Total Maximum Daily Loads for Chloride and Indicator Bacteria in Alamo River, Imperial County

REVISED DRAFT STAFF REPORT

Revised September 2025

Figure 5: Map of Salton Sea Watershed

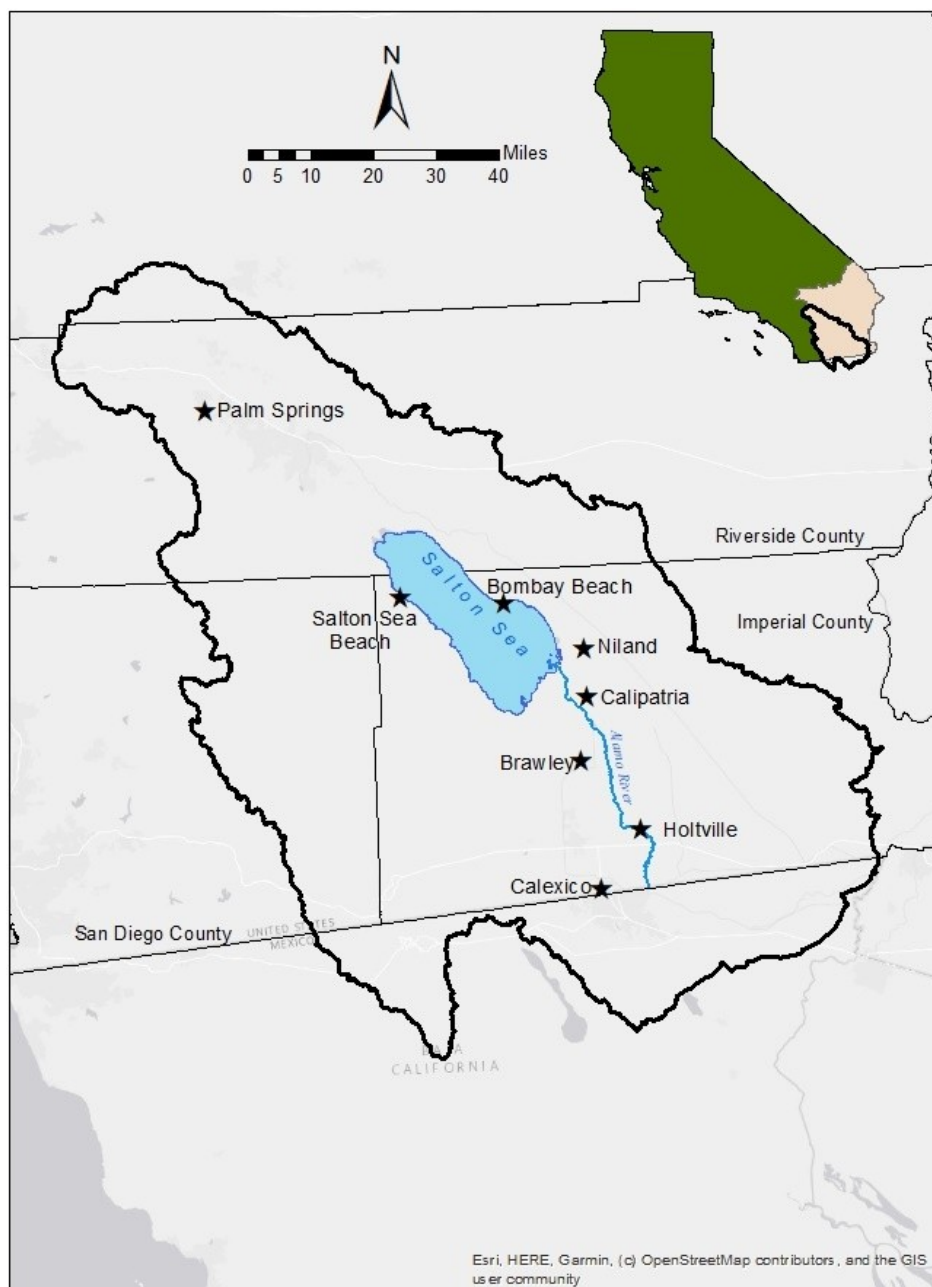
To support analysis and conclusions made later in the report, I would suggest adding (1) tributaries, and (2) land use data to Figure 5. From the current version of Figure 5 it is difficult to understand what the size and land use variations for each of the sampling points are. It would also help to individually delineate the contributing areas to each point and provide the boundaries of said delineations to the map as well.

Figure 8: Chloride Concentrations at Multiple Sites on Alamo River

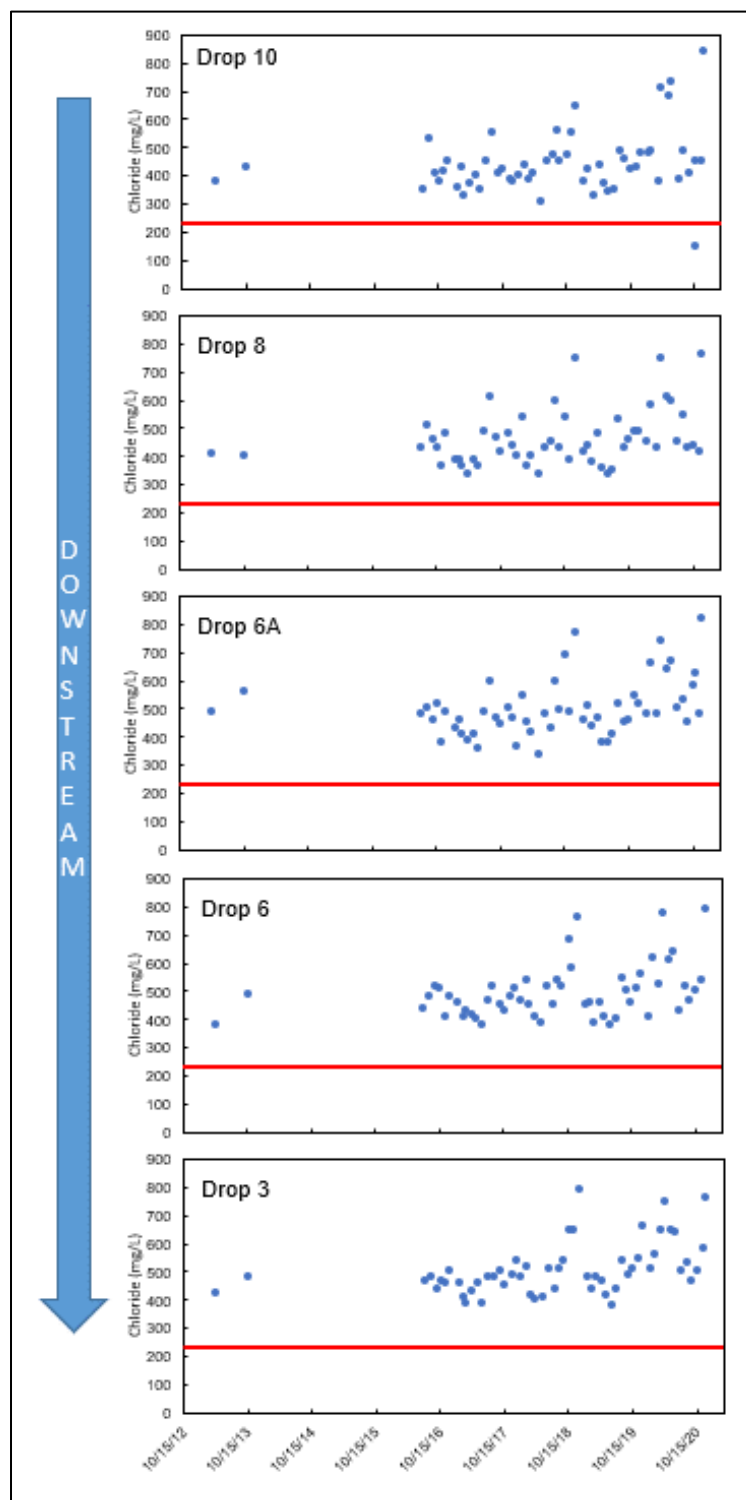
Figures 6 and 7 provide chloride concentrations over time at multiple sites (Figure 6) and at the outlet of the Alamo River (Figure 7). To conclude that these trends “could reasonably be expected to continue with implementation measure laid out in Section 8” would require more details. For example, in Figure 6 there appears to be higher

observations in recent data, with the lower values also being higher in recent years. A slight upward shift in Figure 7 data is also seen, but without statistical testing it is hard to say if this is a significant shift. However, given that all of these data points are above the 230 mg/L chloride WQO it can be reasonably expected that the chloride exceedance could be expected to continue even with implementation measures laid out in Section 8.

For Figures 6-8, it would also be beneficial to overlay these observations with at least the flow seen at the outlet of the watershed to better assess the flow conditions under which the observations were made (or at least include a statement). Trends in water quality across surface water systems are highly dependent on flow so this key detail would be beneficial.

Figure 10: *E. coli* in Alamo River Outlet, 2016 to 2020⁷

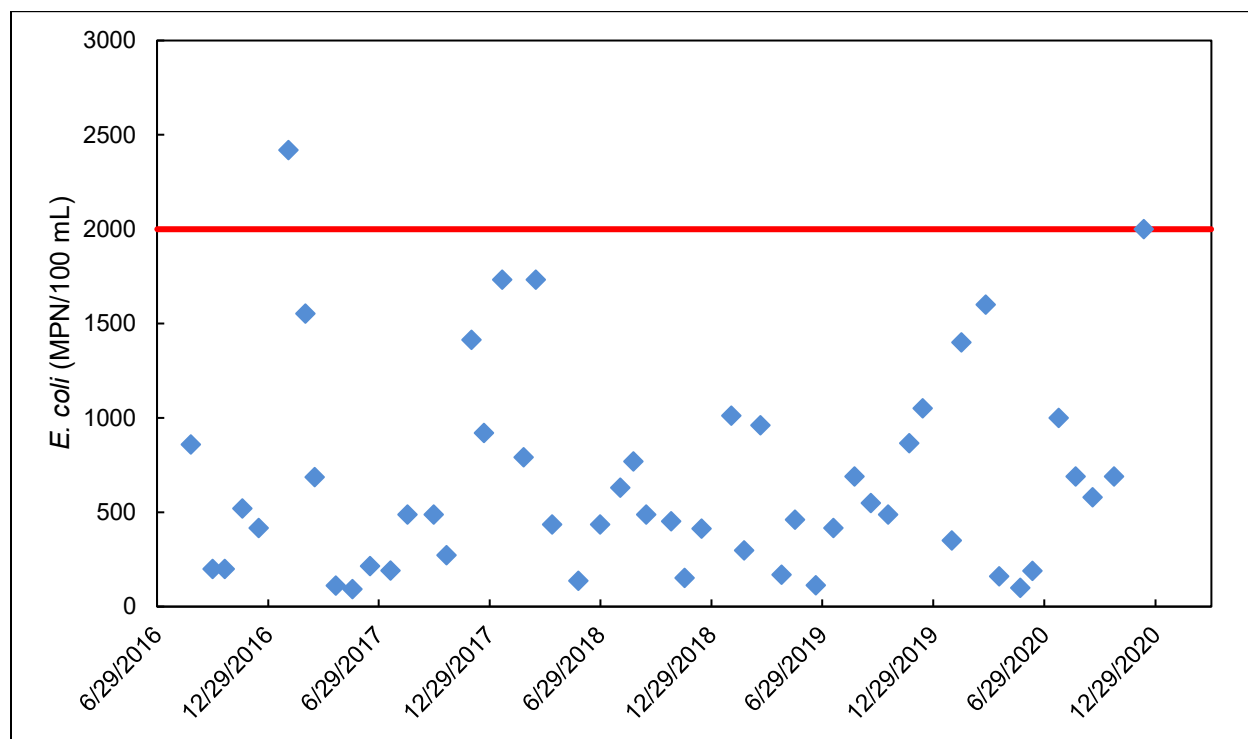
Figure 8 provides *E. coli* concentrations at the Alamo River Outlet while Figure 9 provides *E. coli* concentrations reported from NPDES permitted facilities indirectly draining to the Alamo River. No observable trend is seen in either Figure 8 or Figure 9 such that these trends could be expected to continue and remain below the WQO of the maximum allowable 2000 MPN/100mL concentration value, especially given implementation measure laid out in Section 8.

Figure 11: *E. coli* Data from NPDES Facilities Indirectly Draining to Alamo River⁸

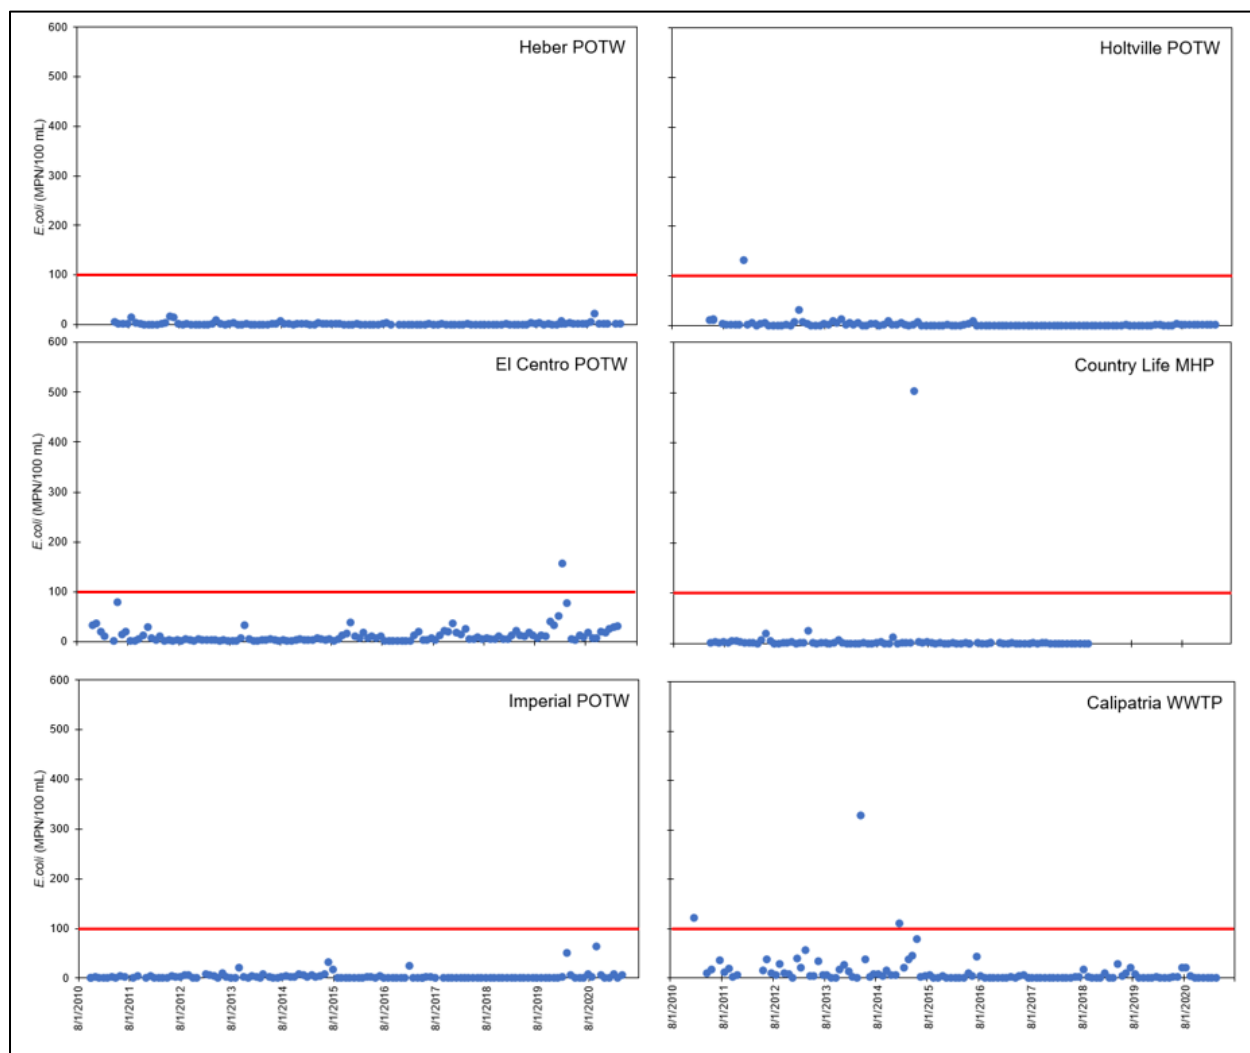
the statements in this section could benefit from evidence or support that will improve their defensibility. For example, the report could directly reference Figure 9 from section 5 when describing the low indicator bacteria levels in the NPDES permitted facilities. I would repeat my comment from above though and note that having the locations of these facilities as well as the CAFOs on the map in Figure 1 or Figure 5 would benefit interpretation of conclusions.
